エアーニッポン株式会社所属ボーイング式737-700型JA16AN航空重大インシデントに係る安全勧告に基づき講じた措置について(通知)

This is our initial and final response to Federal Aviation Administration (FAA) Safety Recommendation 15.031, issued by the Japan Transport Safety Board (JTSB) on September 19, 2014, and received by the FAA on January 28, 2015. The JTSB issued this safety recommendation regarding a Boeing 737-700 (B 737-700), registered JA16AN, operated by Air Nippon Co., Ltd., as the scheduled flight 140 of All Nippon Airways Co., Ltd., (ANA) following an airplane upset event that occurred on September 6, 2011. During cruise, the pilot inadvertently operated the rudder trim switch while intending to unlock the flight deck door. The autopilot initially countered the airplane roll, due to the rudder deflection, with an opposite wheel command. When the autopilot reached its authority limit, the airplane began to roll and pitched nose down resulting in a significant altitude loss and heading change before control of the airplane was recovered by the pilot. The FAA became aware of this incident in 2011 and began work to investigate and mitigate the issue at that time.

SUBJ: Flight Controls

SAIB: NM-15-03

Figure 1 – Rudder Trim Switch

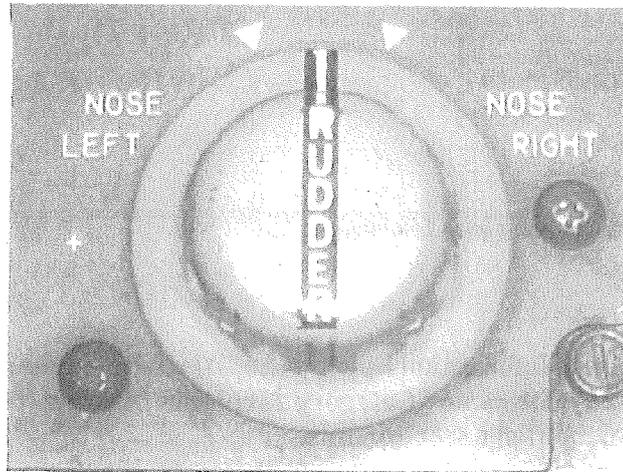
During the investigation of this incident, numerous aisle stand configurations were identified due to the multitude of supplemental type certificate installations and significant variability in the Boeing-delivered configurations. On the incident airplane (Model 737-700), the rudder trim switch is in approximately the same location as the flight deck door control switch on the operator's Model 737-500 airplane. This creates a potential for confusion when pilots transition between aircraft. Positive training on one model can become negative when the pilot transfers to a different model. Although the rudder trim switch (Figure 1) and flight deck door control switch (Figure 2) are different in size and shape (cylindrical vs. blade shaped), and the flight deck door unlock side of the switch must be depressed before turning, the general feel (spring force) to actuate the switches is similar; both are spring loaded to the center position. In this incident, the negative transfer error allowed the pilot to think he had operated the correct control, and the similarity of the control's operation exacerbated the situation.

Having a consistent position for the rudder trim switch is paramount because it provides a direct input to the aircraft rudder and can induce both yaw and roll into the aircraft flight attitude. Because both the rudder trim switch and the flight deck door control switch have a similar feel and action (turn and hold), a standard location and sufficient separation between these controls is recommended. Placing the controls in the recommended locations is consistent with most Boeing-delivered airplanes and creates a distinctive reach posture, provides sufficient separation in relation to reach direction from both seats, and provides adjacent tactile landmarks. This includes the railing in the corner of the aisle stand and the guarded stabilizer trim switch located between the rudder trim switch and the flight

1. Place the rudder trim switch in the center column as far aft as possible.
2. Place the flight deck door control switch in the far right column (first officer side) aft position.
3. Do not place the flight deck door control switch in the center column.

Figure 2 – Flight Deck Door Control Switch

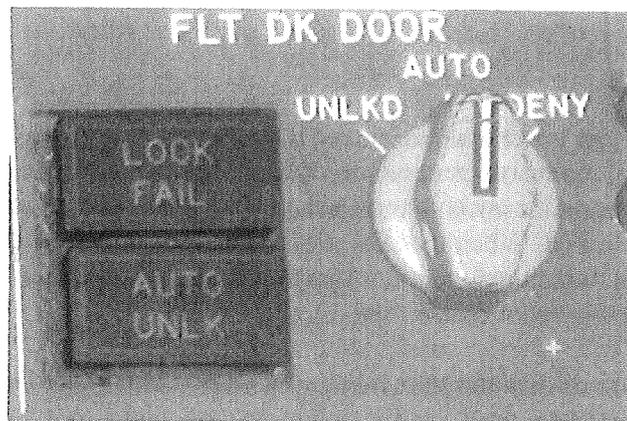
In response to this incident, Boeing analyzed modifying the shape of the flight deck door control switch; however, they determined the position of the switch is more important than the shape of the switch from a human factors perspective. Position of a switch that affects pilot reach/posture provides better feedback to the pilot than the shape of the switch that the pilot feels. Boeing determined the most important factor to minimize inadvertent activation of the control switches is aisle stand configuration consistency within an operator's fleet.
